**Town of Rotterdam
Planning Commission
May 2, 2023**

2. Poentic Kill, LLC (Lessee) – 635 Mariaville Road. Preliminary Site Plan/Special Use Permit review for a 5-megawatt battery storage facility on a ±2.23-acre parcel. Engineer: Empire Engineering, PLLC.

OWNER/APPLICANT:
THE PRETTY PAW LOUNGE
370 MARIAVILLE ROAD
SCHENECTADY, NY 12305

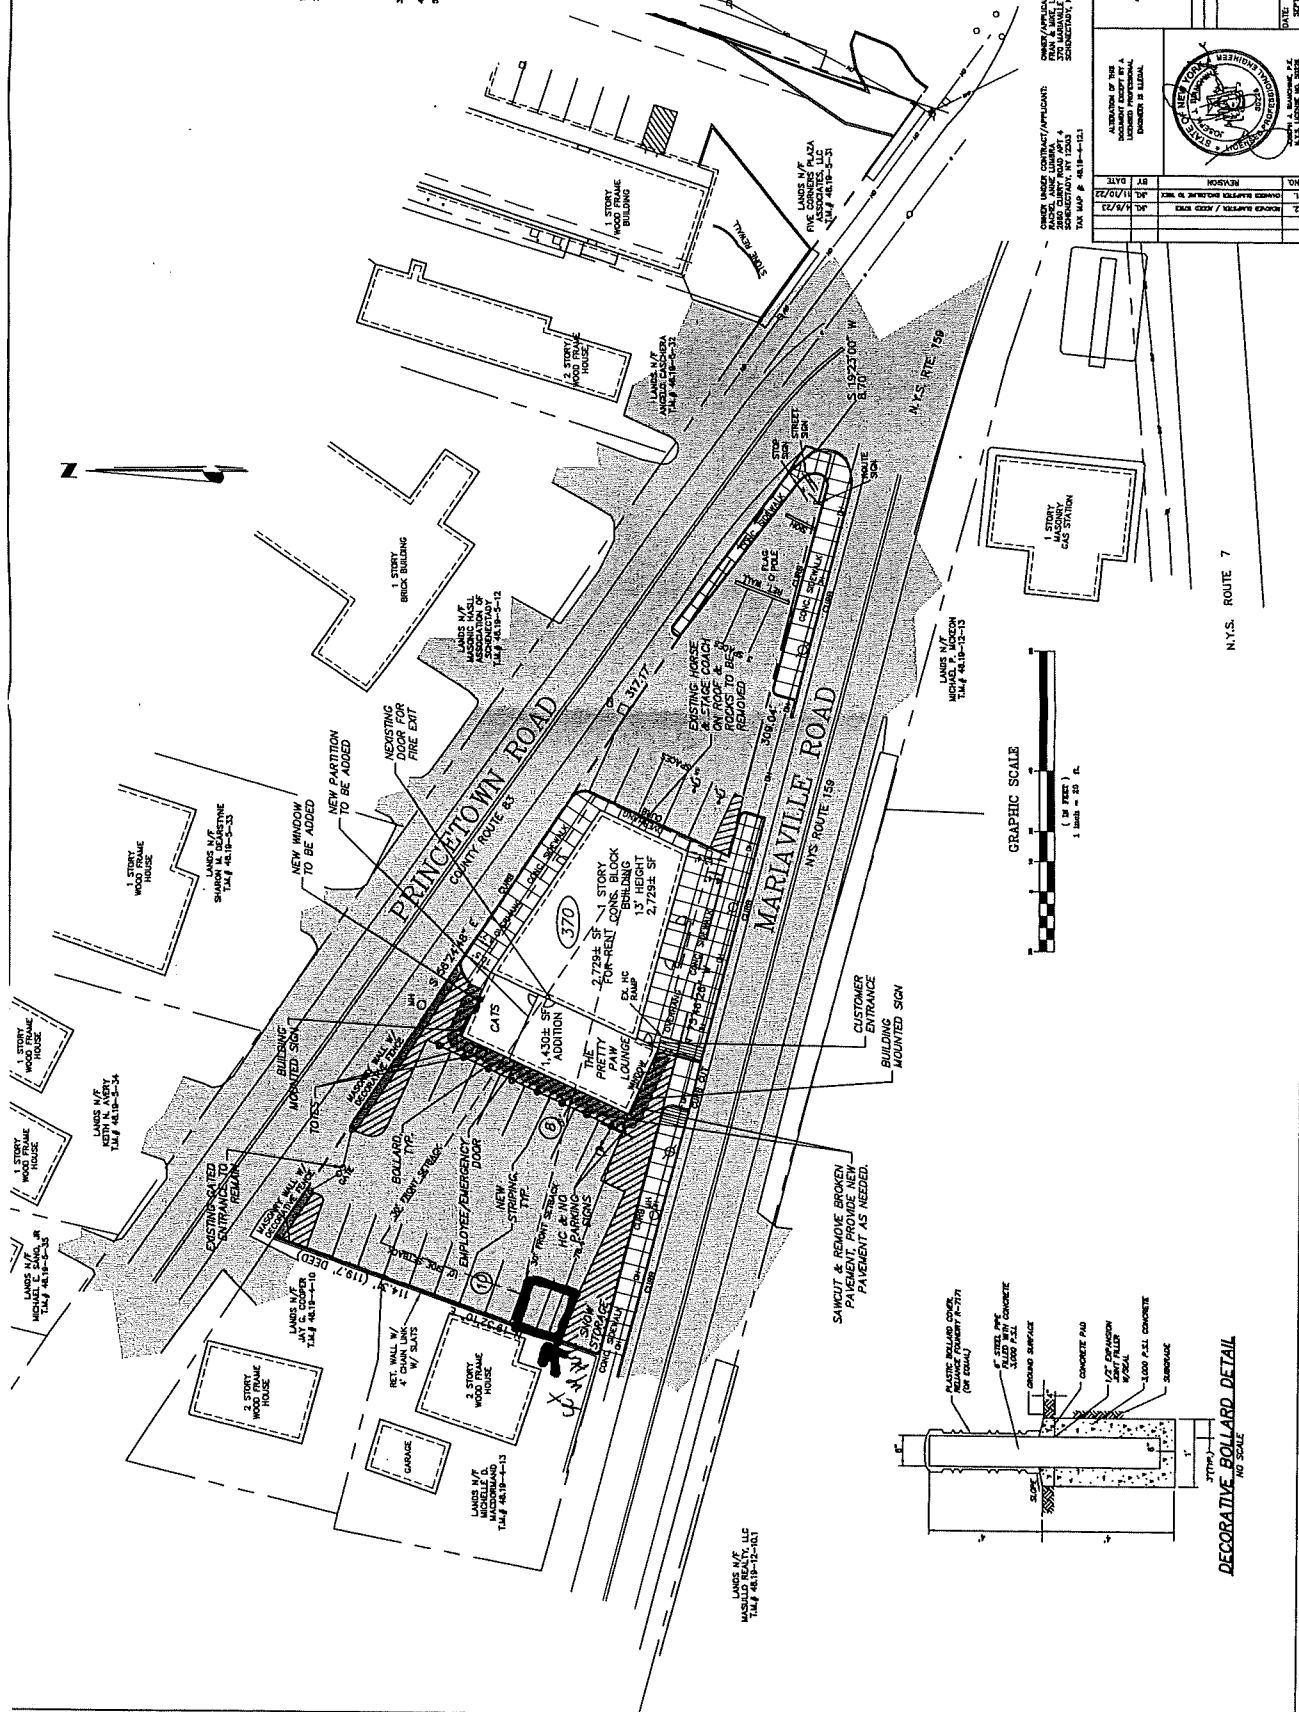
REQUEST: The applicant requests a Waiver of Site Plan for the Seasonal Sale of hot dogs from May 3, 2023 – September 3, 2023 in designated area as depicted on application site plan of the cat lounge adoption center.

1. Compliance with all NYS Building and Fire Codes.
2. Applicant to comply fully with Town Sign Code and obtain a building permit for any signage.
3. Applicant shall obtain Schenectady County Health approval and/or New York State Department of State licensing.
4. All parking for site activity to occur on-site in area designated on site plan. No parking is to occur on public highway.
5. Ingress/egress onto Princetown Road & Mariaville Road shall remain free and clear at all times.

↑ 6,800sf
Houses
Playground

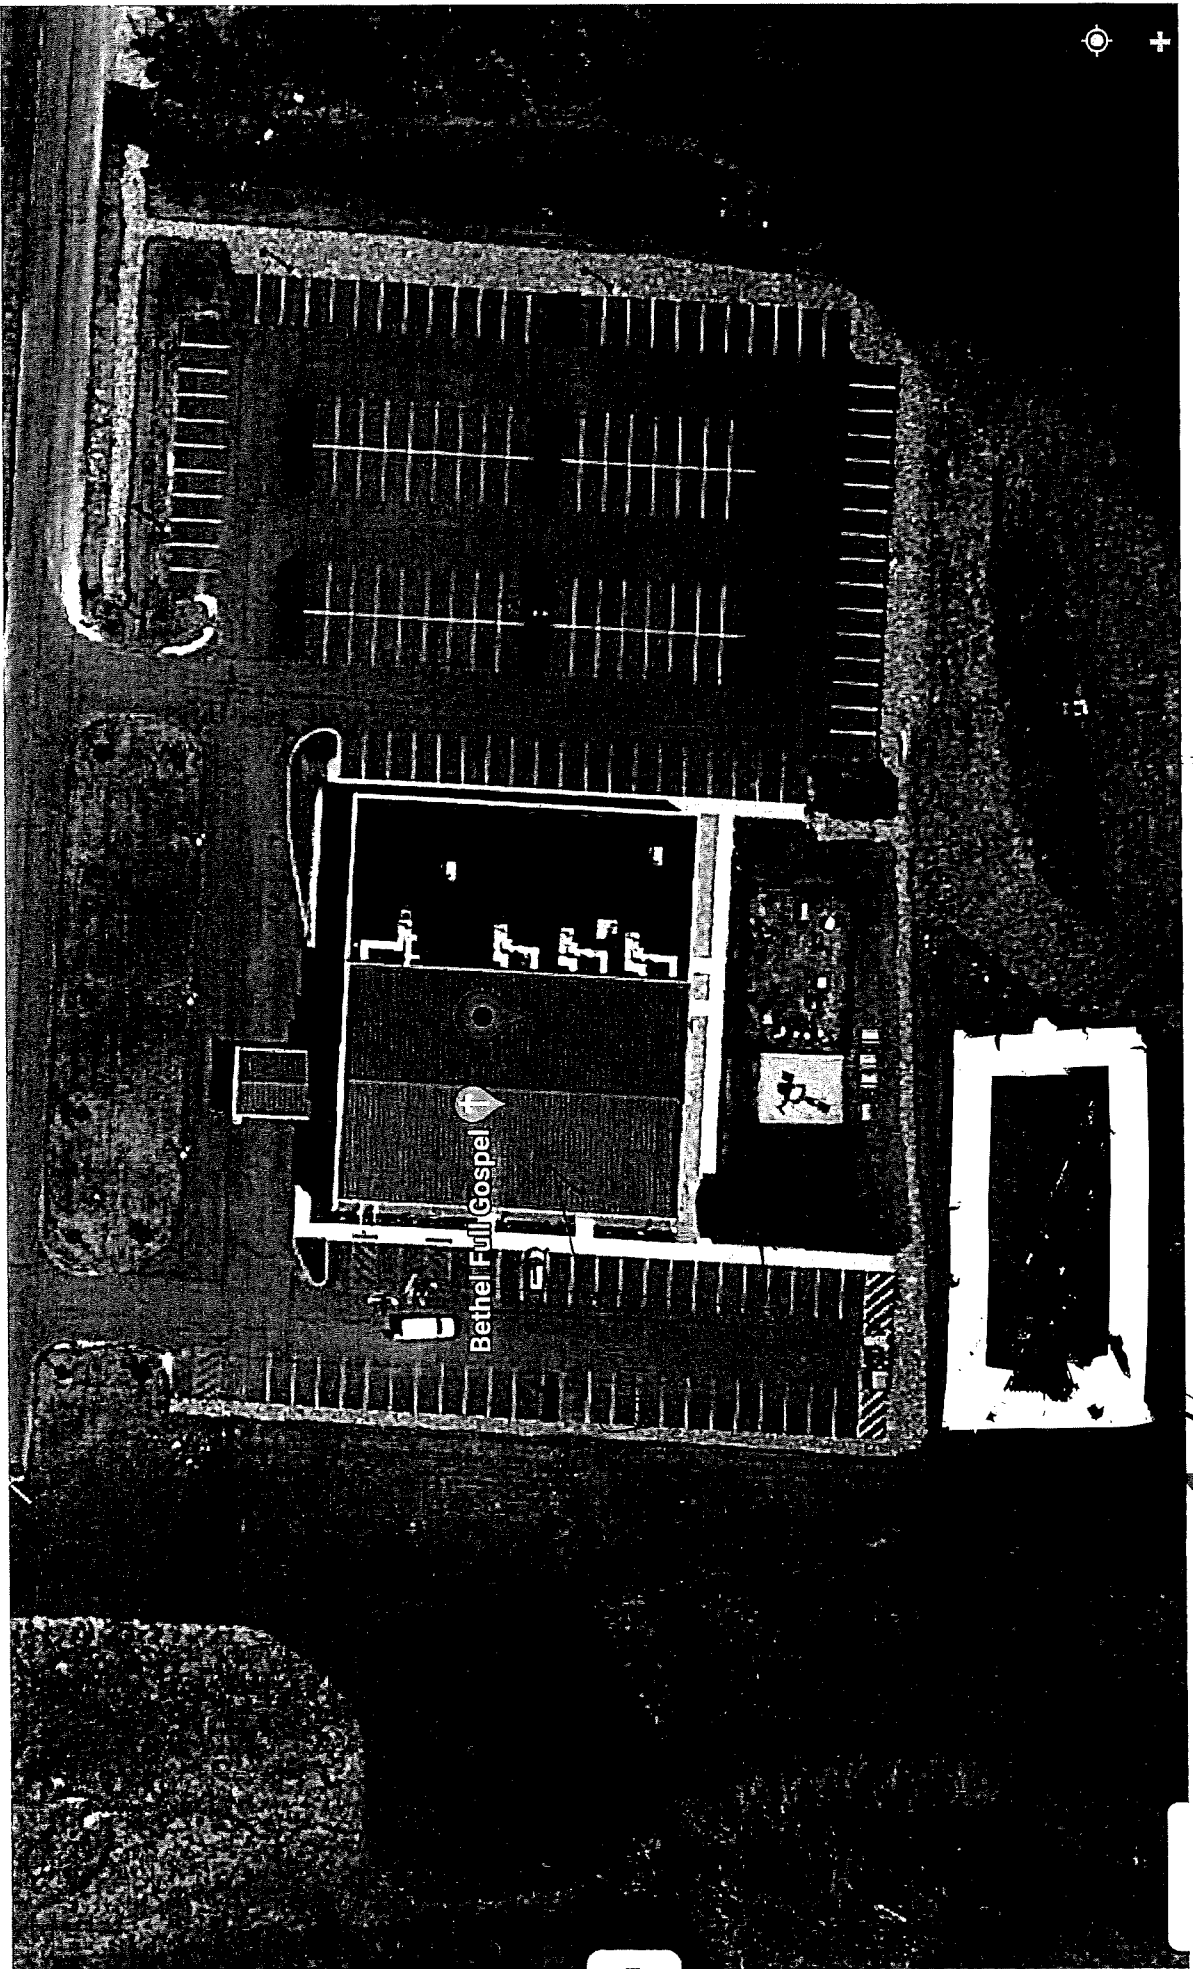
REQUEST: The applicant requests a Waiver of Site Plan review to create a 6,800 square foot playground on the south side of existing church on a ±43.7 acre parcel.

1. Compliance with all NYS Building and Fire Codes.
2. Applicant to comply fully with Town Sign Code and obtain a building permit for any signage.
3. Applicant must obtain a Fire Inspection and/or Building Permit and be issued a Certificate of Occupancy from the Town of Rotterdam Building Inspector/Code Enforcement Officer prior to operation.
4. Submit Notice of Termination for NYS DEC Authorization NYR11B432 to DPW for acceptance and provide documentation from DEC that the authorization has been terminated prior to issuance of a building permit.
5. Check with NYS Office of Children and Family Services to determine if fencing is required.

PROPOSED SUBDIVISION AND ZONING CHANGE

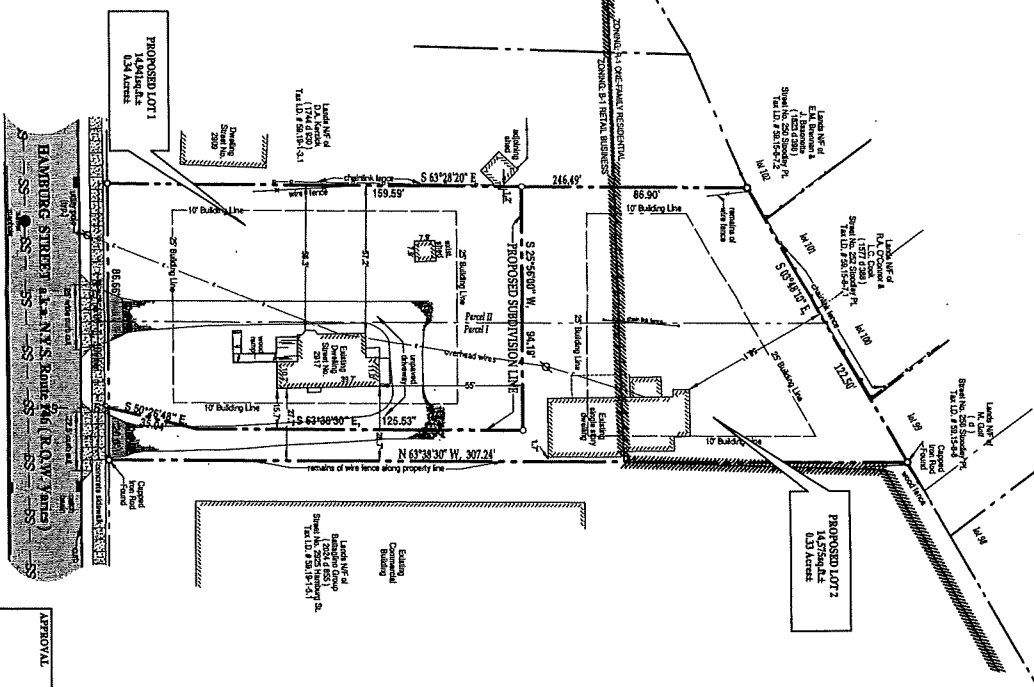
The town should require both properties to hook into the municipal sewer system. Utility connections should be shown on the plans. The lot line for the key hole lot where it meets Hamburg Street should be modified slightly (extended to the north) to encompass the access drive completely.

2. Add note to final subdivision: “The Zoning Board of Appeals has granted lot width and lot size variances on April 19, 2023.”
 3. Add note to final subdivision: “Lot #1 shall connect to sanitary sewer prior to Chairman’s Signature. Existing septic will need to be abandoned and decommissioned.

4. Add note to final subdivision: “Lot #2 shall connect to public sewer prior to the issuance of a building permit. Existing septic will need to be abandoned and decommissioned.”
